Docket Number:	12-AFC-03
Project Title:	Redondo Beach Energy Project
TN #:	205096
Document Title:	Applicant's Comments on the Preliminary Staff Assessment " Visual Resource Assessment
Description:	N/A
Filer:	Cindy Salazar
Organization:	CH2M HILL
Submitter Role:	Applicant Consultant
Submission Date:	6/19/2015 2:05:03 PM
Docketed Date:	6/19/2015

Subject: Redondo Beach Energy Project (12-AFC-03)
Applicant's Comments on the Preliminary Staff Assessment – Visual Resource Assessment

Applicant's Comments on the Preliminary Staff Assessment

FIGURE PSA-VIS-1
Aesthetic Treatment Plan –
Conceptual Plan View
 AES Redondo Beach Energy Project – PSA Comments
 Redondo Beach, California

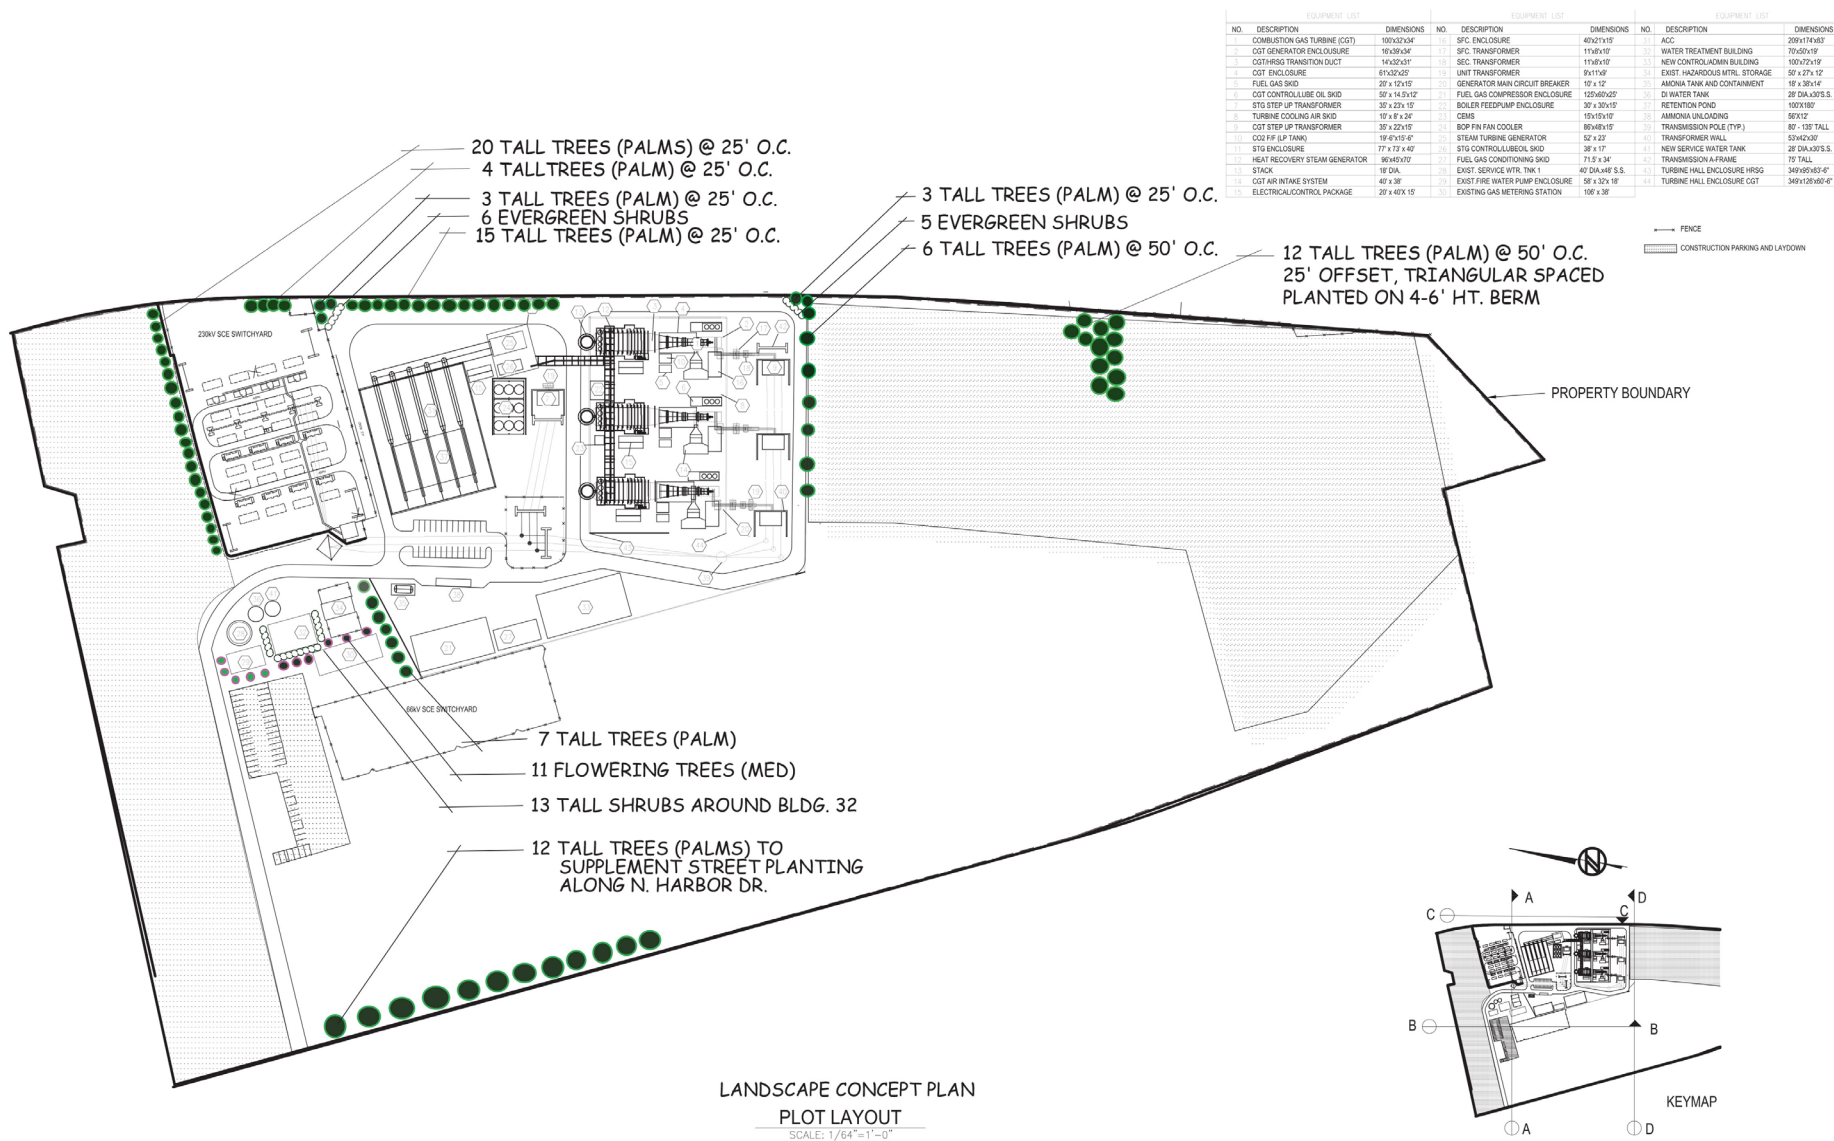
In the PSA, CEC staff recommended the development of a “Site Screening and Landscape Concept Plan” and provided a variety of options. In response, an “Aesthetic Treatment Plan” has been submitted in to the CEC on June 4, 2015 (TN 204902). The Aesthetic Treatment Plan includes enhancements to the Landscape Concept Plan initially developed for RBEP, along with conceptual color treatment for the proposed RBEP. Specifically, the Aesthetic Treatment Plan:

- Adds vegetation within the project site boundary along the northern edge of the switchyard near Herondo Street, east of the power block and air-cooled condenser (ACC), and in the southeastern portion of the project site, adjacent to the Information Technology Center surface parking area; these additions are intended to enhance screening of portions of the project as visible from the north, east and south.
- Incorporates the orange and tan color tones, found on existing building exteriors in the adjacent harbor and commercial areas, into the power block enclosures, ACC, and other visible features, with the exception of the HRSG stacks.

Figure PSA-VIS-1 shows the enhanced landscape concept component of the Aesthetic Treatment Plan, and Figure PSA-VIS-2 shows the conceptual landscaping on an aerial base. The conceptual color treatment component is shown in the revised simulations for views from KOP 5, KOP 8 and KOP 9. In the revised view from KOP 5 (Figure PSA-VIS-3), additional landscaping and applied color treatments are visible in the simulated (B) view. Figure PSA-VIS-4 shows an expanded, panoramic view from KOP 5, which indicates the broader positive effects on views in the vicinity with the removal of RBGS. The updated existing view from KOP 8 (the A image in Figure PSA-VIS-5) reflects recent commercial development activities along Catalina Avenue, which include a screen that obscures a lower portion of the RBEP in the simulated (B) view. In the revised view from KOP 9 (Figure PSA-VIS-6), the conceptual color treatment as simulated relates to other visible buildings and the lower portions of turbine enclosures are partially screened by the enhanced landscaping.
